SUBJECT: CERTIFICATION OF THE MINUTES OF THE ACRS FUTURE PLANT
DESIGNS SUBCOMMITTEE MEETING ON THE TECHNOLOGY NEUTRAL
LICENSING FRAMEWORK (WORKING DRAFT NUREG-1860) MARCH 7,
2007, ROCKVILLE, MARYLAND

**ADVISORY COMMITTEE ON REACTOR SAFEGUARDS
FUTURE PLANT DESIGNS SUBCOMMITTEE MEETING MINUTES
MARCH 7, 2007
ROCKVILLE, MARYLAND**

The ACRS Subcommittee on Future Plant Designs met on March 7, 2007, at 11545 Rockville Pike, Rockville, Maryland, in Room T-2B3. The purpose of this meeting was to review the NRC staff's work on technology neutral licensing framework (i.e., Working Draft NUREG-1860) with a focus on ensuring the value of such an approach versus the development of a licensing framework for specific designs, such as a high temperature gas cooled reactor or a liquid metal cooled reactor (reference the Commission's November 8, 2006, Staff Requirements Memorandum to Dr. Larkins). During the briefing, the Committee also explored with the NRC staff the pros and cons of developing a licensing framework for specific designs. The Subcommittee gathered information, analyzed relevant issues and facts, and formulated proposed positions and actions, as appropriate, for deliberation by the

Figure 6-3 Frequency-consequence curve.

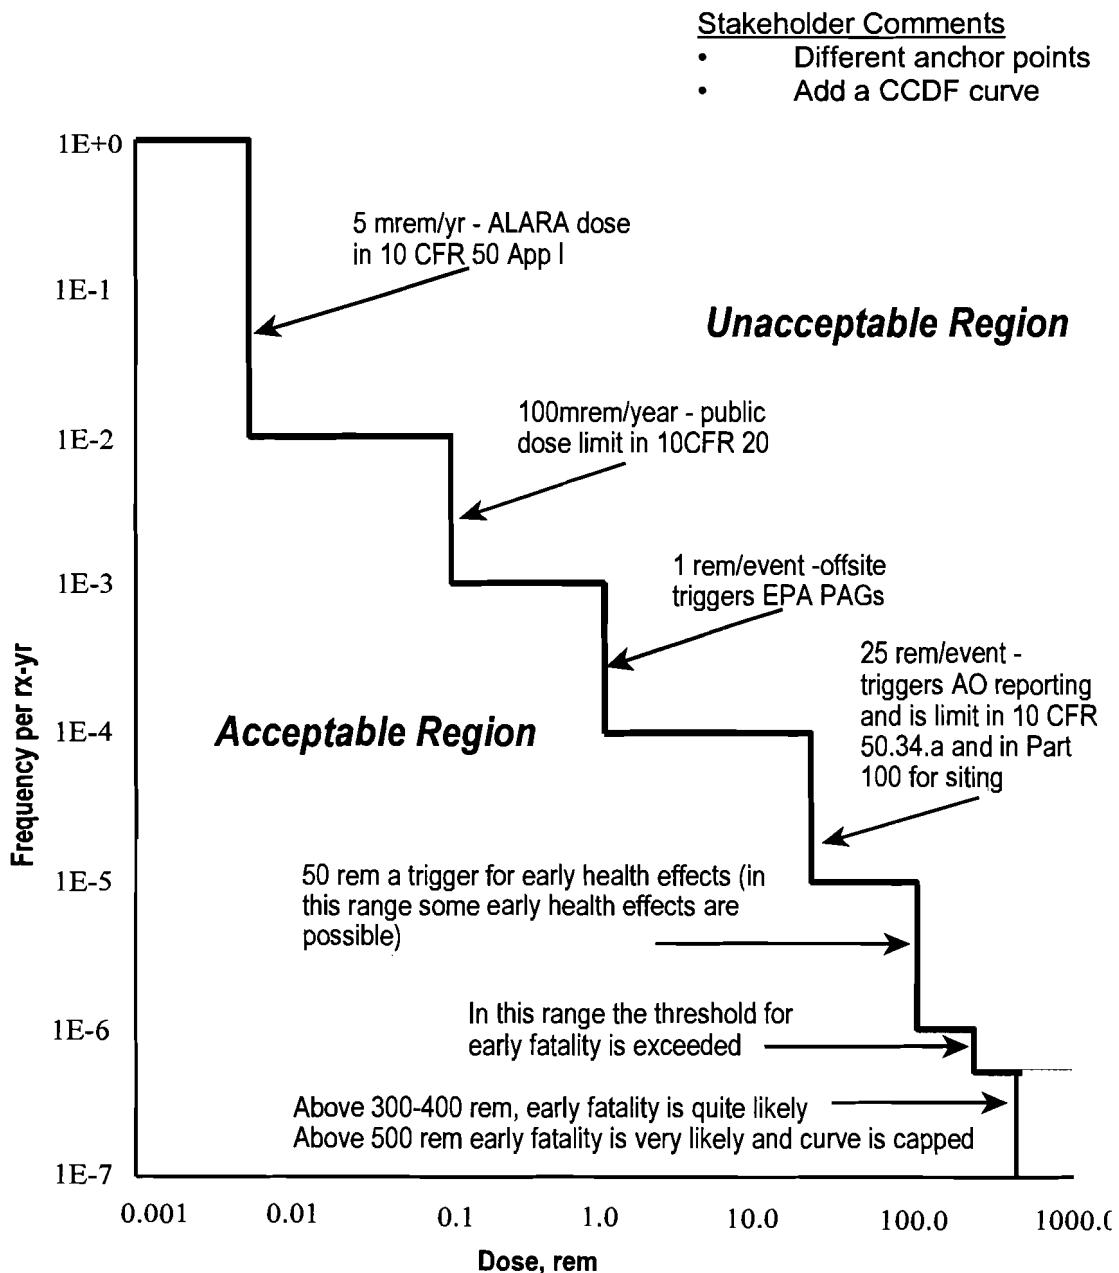
The subcommittee spent a considerable amount of time discussing the frequency-consequence (F-C) curve contained in draft NUREG-1860 (i.e., Figure 6-3).

Dr. Kress questioned why the prosed F-C curve was not replaced with a straight line. With a slope of approximately negative one, the curve shows a risk-aversion towards the end of the curve. The subcommittee and staff discussed the use of a CCDF F-C curve versus use of the QHOs. Dr. Kress expressed concern over using the QHOs because he said they are site-related characteristic. He also said that a plant can be designed to meet the QHOs, but then questioned how one would address a multiple-unit site. Dr. Kress suggested using a CCDF F-C curve, equivalent to a CDF of 10^{-5} and LERF of 10^{-6} , as a design requirement for fission product release. He added that then you could put 10 plants on a site and still meet the QHOs. Dr. Apostolakis expressed concern over making the design curve overly conservative. He favored having separate siting requirements (expanded QHOs that perhaps address societal things). Dr. Apostolakis said that for the Committee to make an informed decision on the framework it needs to know, in detail, what other organizations have proposed and how they differ with the staff. The subcommittee discussed the need for writing a Committee letter on the framework (i.e., to respond to the November 8, 2006 SRM, to provide the staff with its comments on technical/policy aspects of the framework). Ms. Drouin said that public comments on the framework were generally favorable, at the conceptual level, but most indicated that they wanted to see it tested before the staff proceeded with rulemaking. She said that the staff did a very limited test of the framework on an existing LWR and that the July version of the framework reflects that test. She said that a more complete test of how the framework translates into actual requirements will be published in the version of the framework they plan on issuing early this summer. The version to be published early this summer would also contain an appendix that summarized all the stakeholder comments. The subcommittee discussed the possibility of testing the framework on an actual plant (e.g., PBMR, NGNP). Mr. Ruben, part of an inter-office team looking at the licensing strategy for the NGNP, described several licensing approaches being considered by the staff, each with varying degrees of the use of PRA information. The spectrum of options includes 1) using a completely deterministic

Figure 6-3 Frequency-consequence curve.

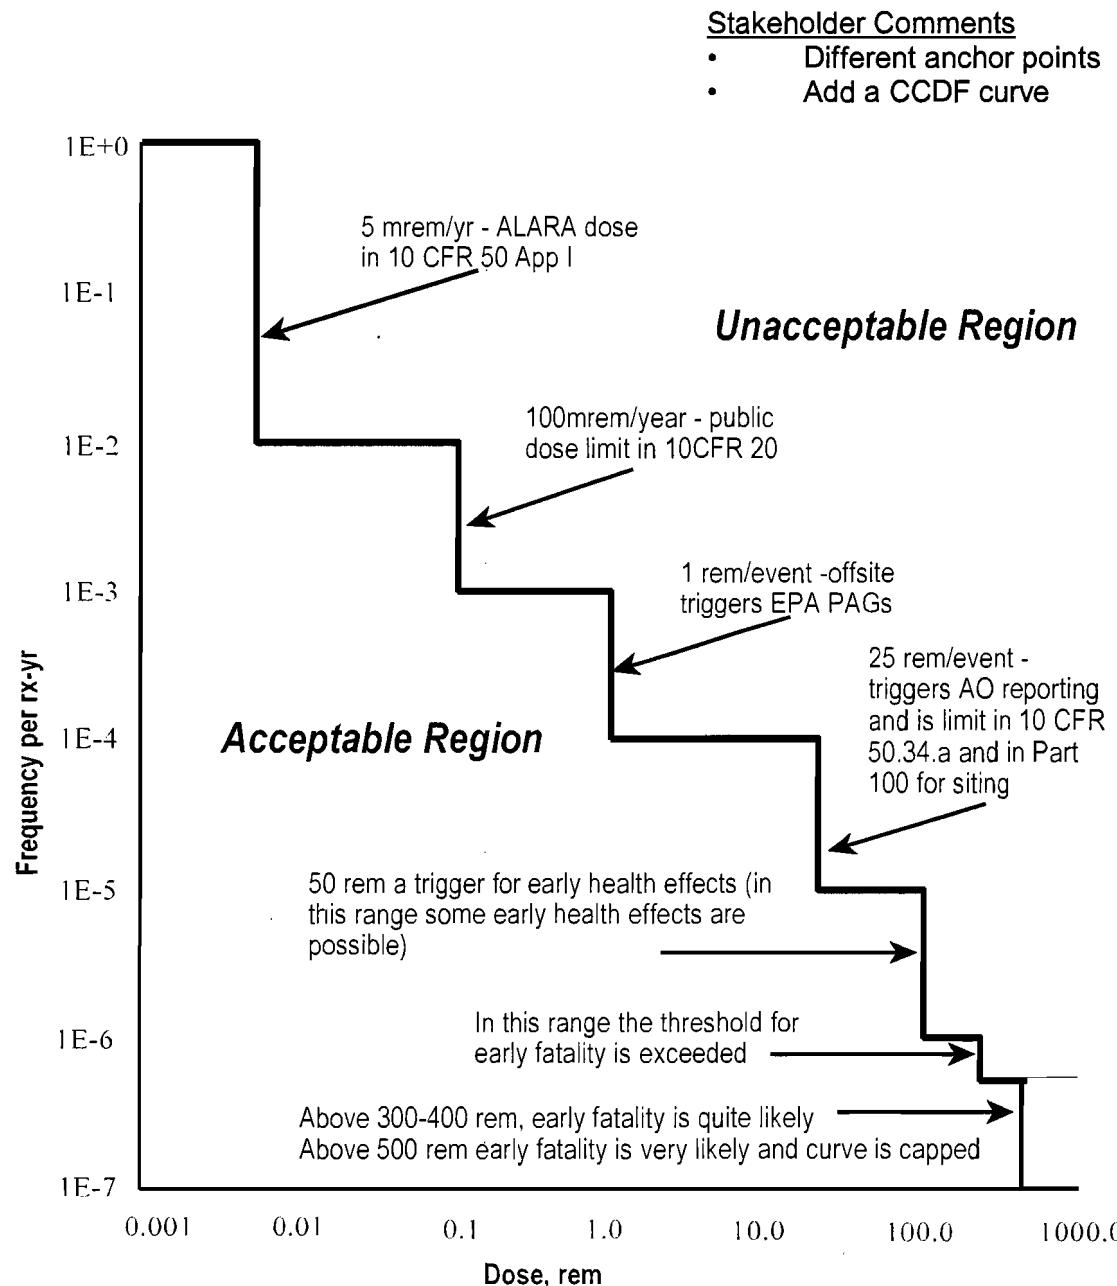
The subcommittee spent a considerable amount of time discussing the frequency-consequence (F-C) curve contained in draft NUREG-1860 (i.e., Figure 6-3).

Dr. Kress questioned why the prosed F-C curve was not replaced with a straight line. With a slope of approximately negative one, the curve shows a risk-aversion towards the end of the curve. The subcommittee and staff discussed the use of a CCDF F-C curve versus use of the QHOs. Dr. Kress expressed concern over using the QHOs because he said they are site-related characteristic. He also said that a plant can be designed to meet the QHOs, but then questioned how one would address a multiple-unit site. Dr. Kress suggested using a CCDF F-C curve, equivalent to a CDF of 10^{-5} and LERF of 10^{-6} , as a design requirement for fission product release. He added that then you could put 10 plants on a site and still meet the QHOs. Dr. Apostolakis expressed concern over making the design curve overly conservative. He favored having separate siting requirements (expanded QHOs that perhaps address societal things). Dr. Apostolakis said that for the Committee to make an informed decision on the framework it needs to know, in detail, what other organizations have proposed and how they differ with the staff. The subcommittee discussed the need for writing a Committee letter on the framework (i.e., to respond to the November 8, 2006 SRM, to provide the staff with its comments on technical/policy aspects of the framework). Ms. Drouin said that public comments on the framework were generally favorable, at the conceptual level, but most indicated that they wanted to see it tested before the staff proceeded with rulemaking. She said that the staff did a very limited test of the framework on an existing LWR and that the July version of the framework reflects that test. She said that a more complete test of how the framework translates into actual requirements will be published in the version of the framework they plan on issuing early this summer. The version to be published early this summer would also contain an appendix that summarized all the stakeholder comments. The subcommittee discussed the possibility of testing the framework on an actual plant (e.g., PBMR, NGNP). Mr. Ruben, part of an inter-office team looking at the licensing strategy for the NGNP, described several licensing approaches being considered by the staff, each with varying degrees of the use of PRA information. The spectrum of options includes 1) using a completely deterministic

Figure 6-3 Frequency -consequence curve

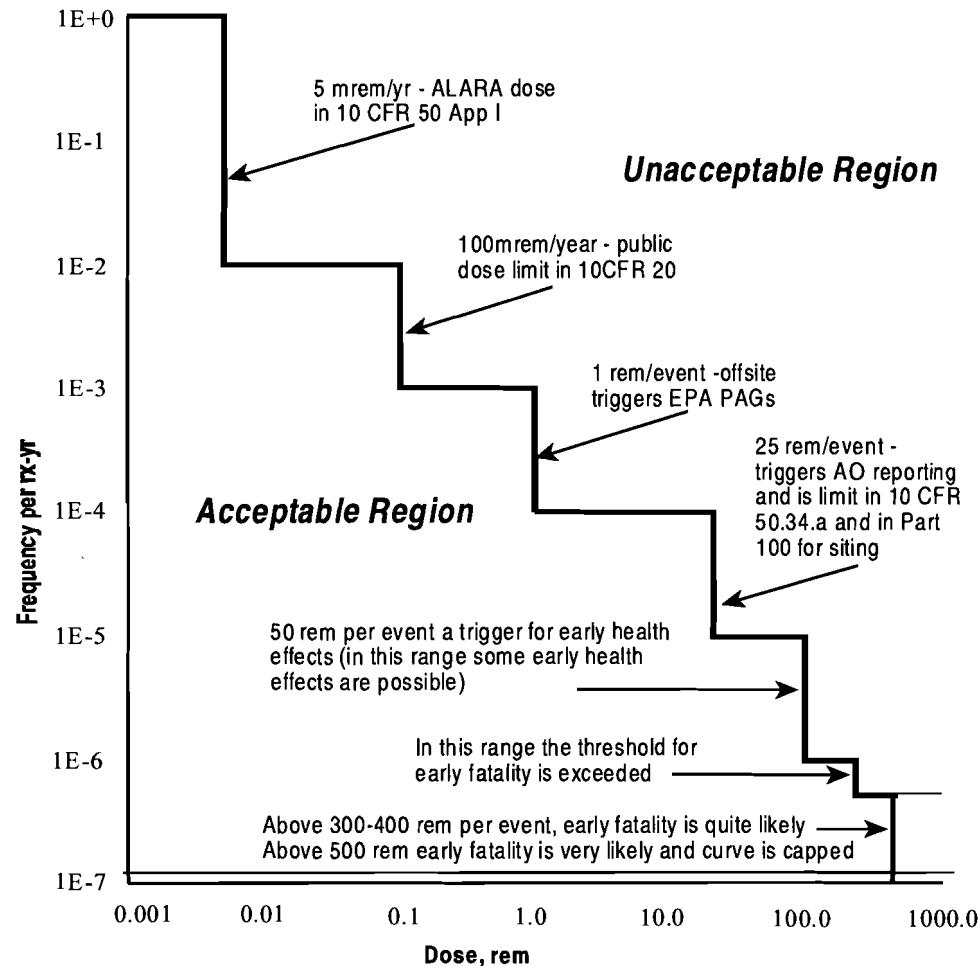
Stakeholder comments:
